**RE: Glendesto Subdivision
Grading Plan and Drainage Report
Engineers Stamp Date: 7/7/17
Hydrology File: B18D020**

***Drainage Management Plan
for
Glendesto Subdivision
(aka Tierra Serena Subdivision)
(27 lots)***

**Re: Glendesto Subdivision – (DRB 1004472)
Amended Preliminary Plat, Grading and Drainage Plan, Sidewalk Variance, Sidewalk Waiver and Deferral.**

**RE: Glendesto Subdivision
Grading Plan and Drainage Report
Engineers Stamp Date: 6/15/17
Hydrology File: B18D020**

SEE SHEET 2 FOR OFF-SITE
GRADING & DRAINAGE

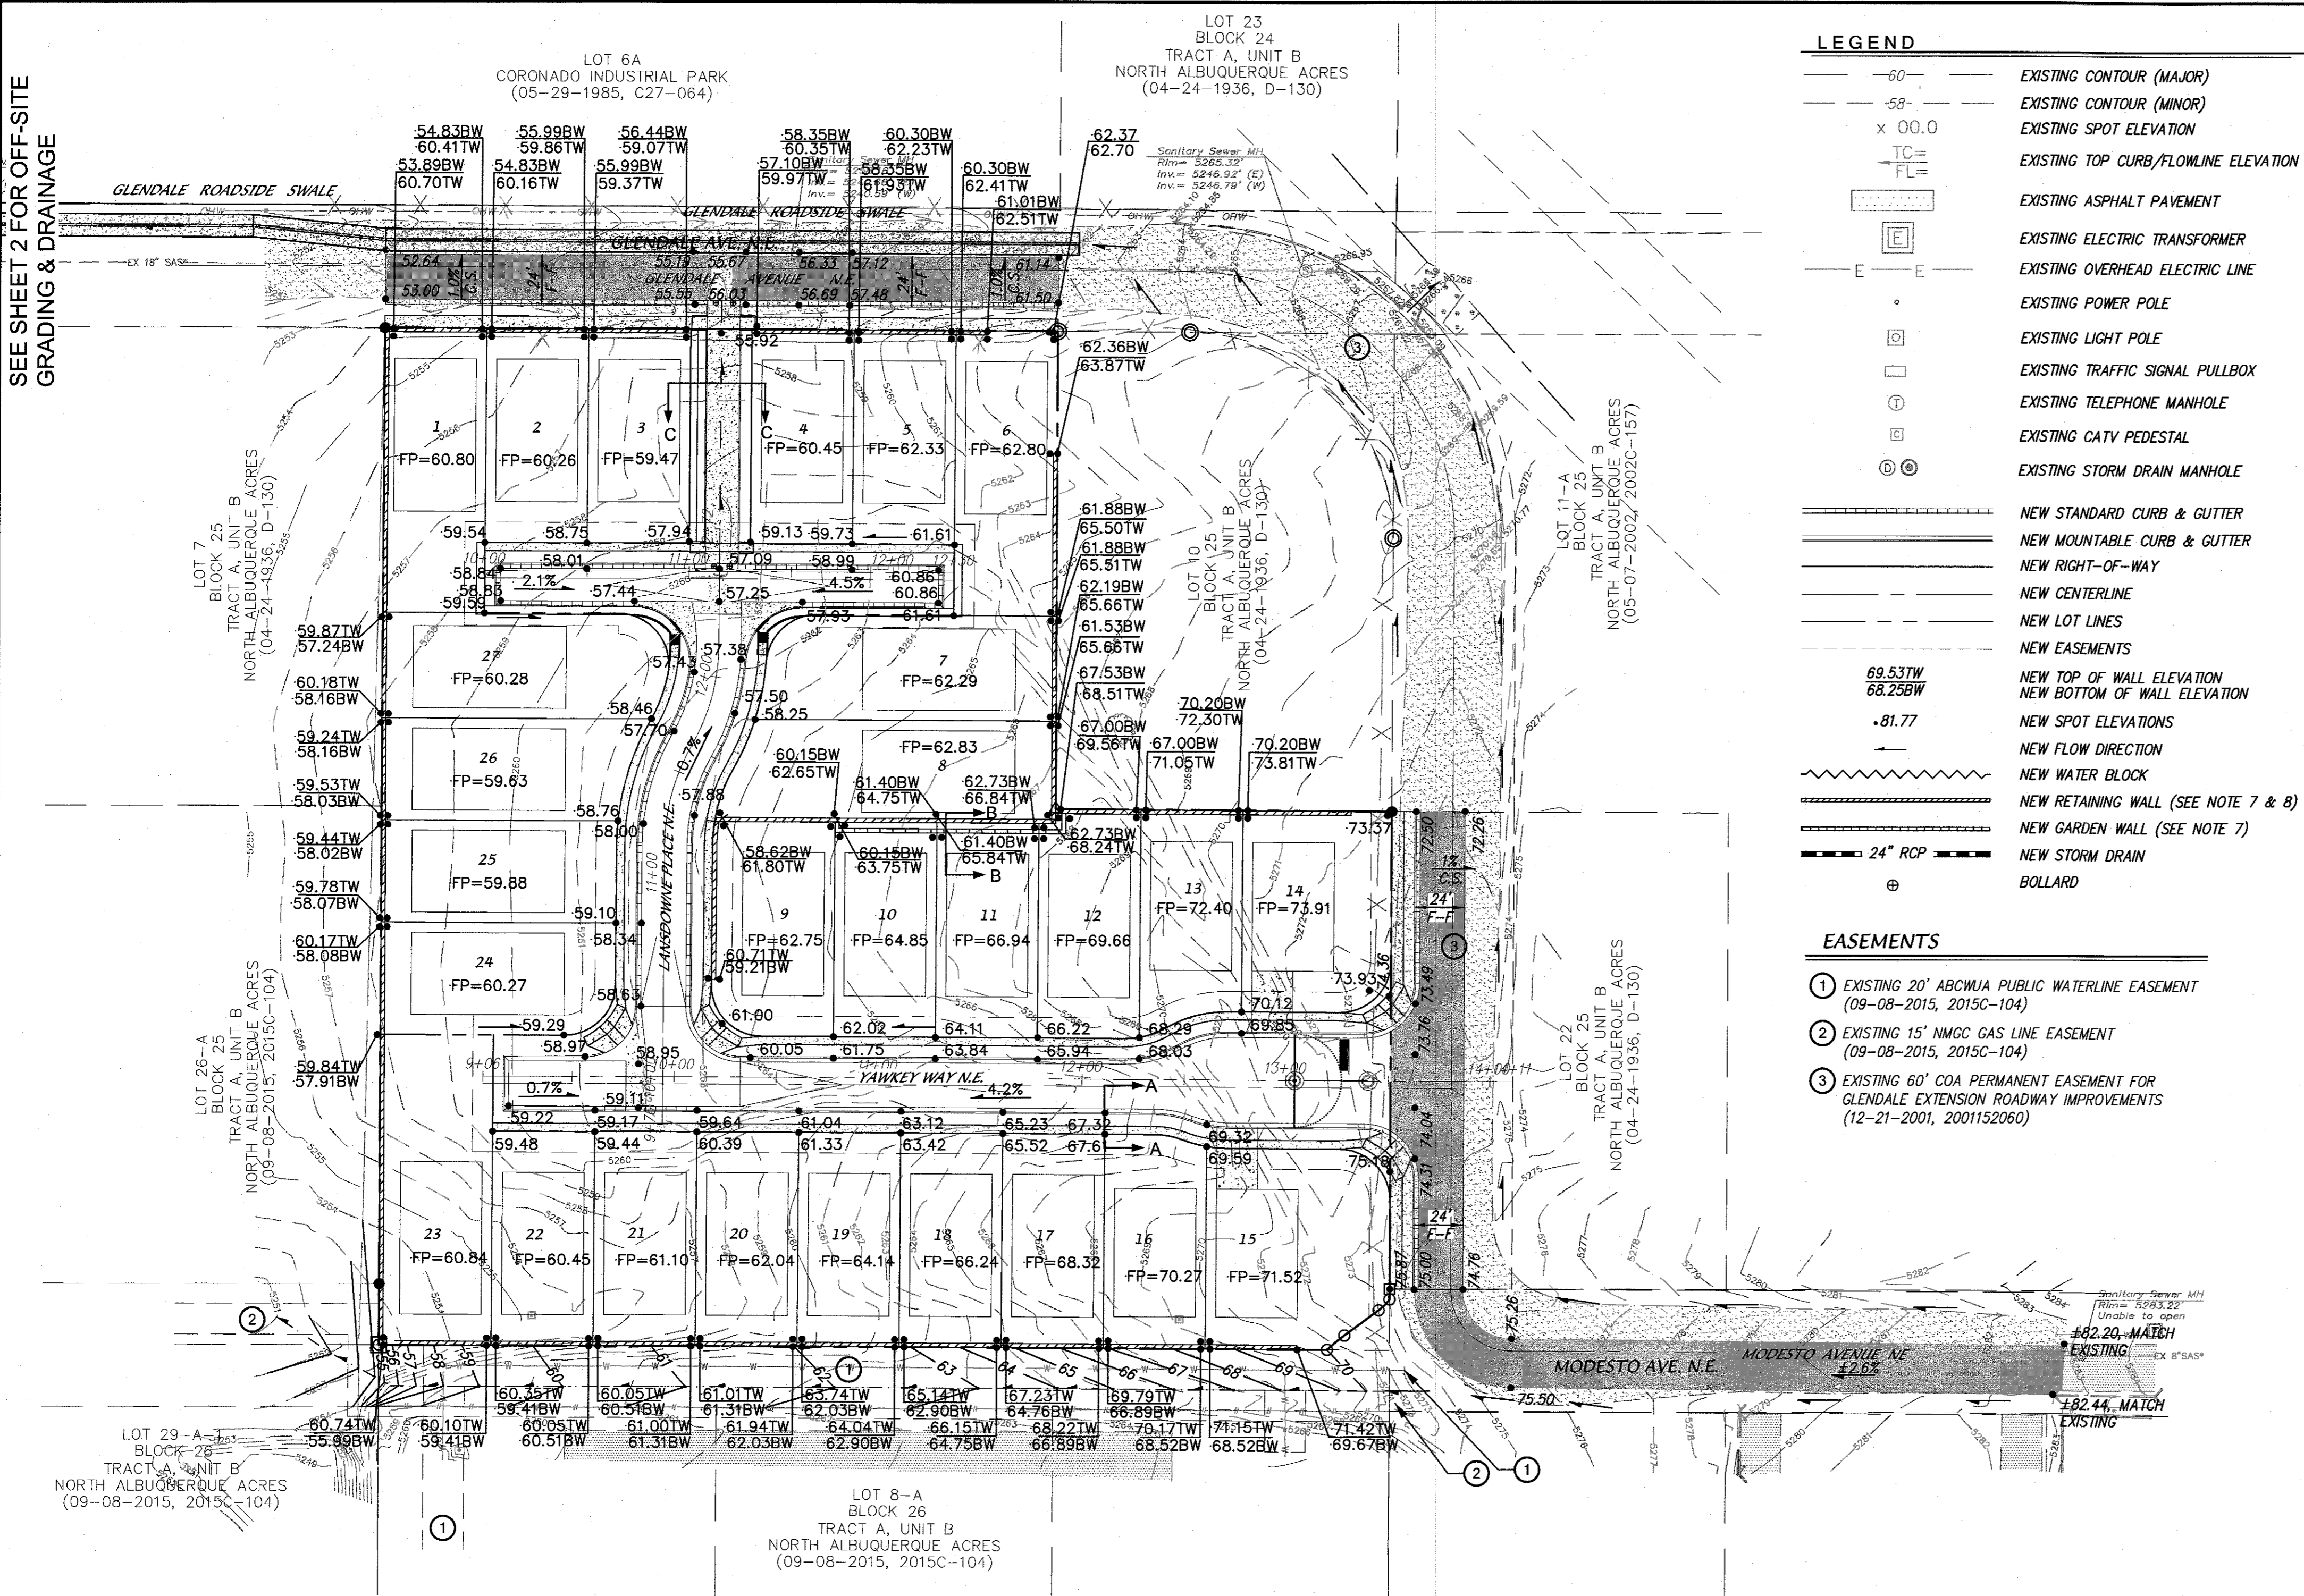
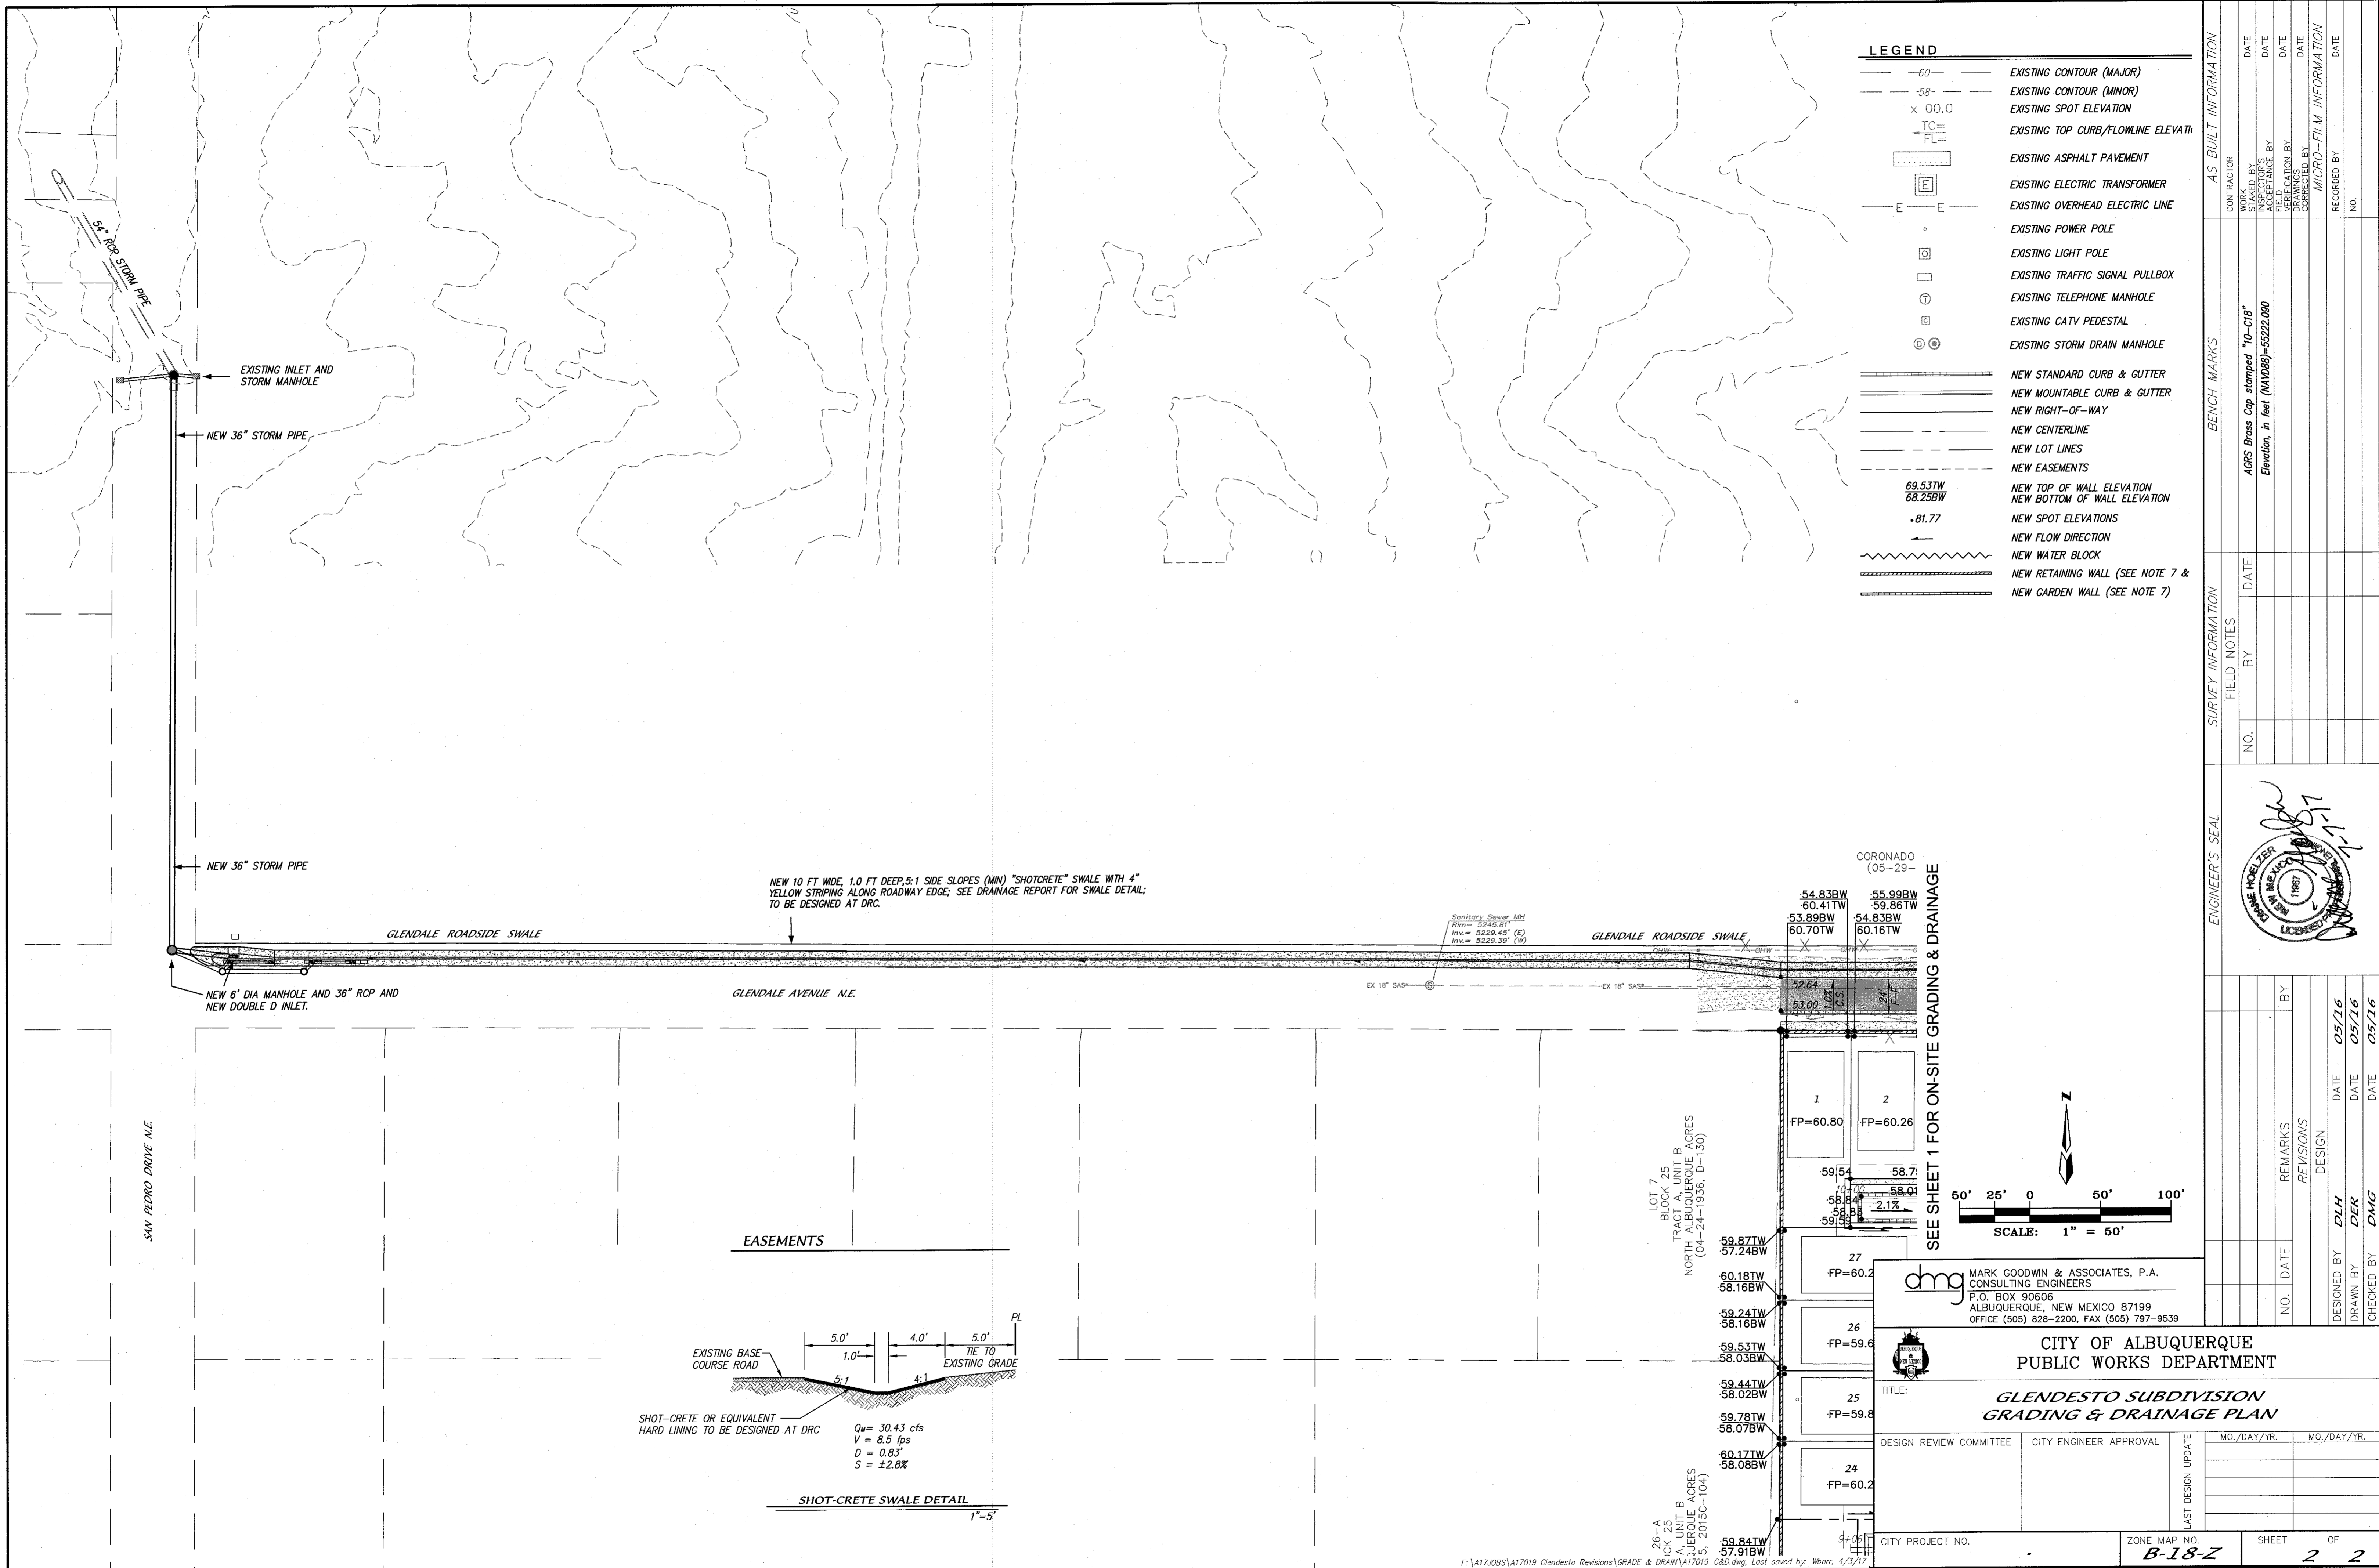
1. The proposed channel on Tract A needs to be designed to accommodate 1.0' freeboard according to Ch. 22 of the DPM. Also the channel top width in the drainage report is 9' wide, but the top width shown on the grading plan is only 5' wide.

2. What happens where the Tract A channel crosses the sidewalks on Glendale and at the hammerhead? It seems like arrays of sidewalk culverts need to be sized and designed here and included on the Infrastructure List.

3. The Glendale roadside channel designed in the drainage report does not match the channel shown on the plans.
4. What happened to the double retaining wall along the west side of lot 23, formerly lot 8? The single retaining wall topped with a garden wall will exceed the 8' maximum and the double wall may infringe on the 5' setback for the pad.

5. Recheck the pad elevations. Many pads have enough elevation difference to require retaining walls in between lots such as: lot 21, and lot 24/25.
6. A revised ESC plan is required prior to Grading Permit approval.

1. The site was lowered to reduce retaining wall height in the southwest corner,
2. A 16' wide drainage channel was placed down the middle of the 30' wide easement,
3. The drainage report was revised to address the Hydrology Dept. comments,
4. A sidewalk design variance is being requested along the south side of the hammerhead street. The Transportation Engineer requested sidewalk on both sides of the hammerhead to create sidewalk continuity within the development. We are asking for a variance along the south side of the hammerhead adjacent to Lots 27 and 7 because if the landscape easement is added there will not be enough width within the lot for the home product planned for this development. The lot depths adjacent to lots 7 and 8 along Yawkey Way are already at a minimum depth of 105 feet.
5. A sidewalk waiver along lot 24 is being requested as well.
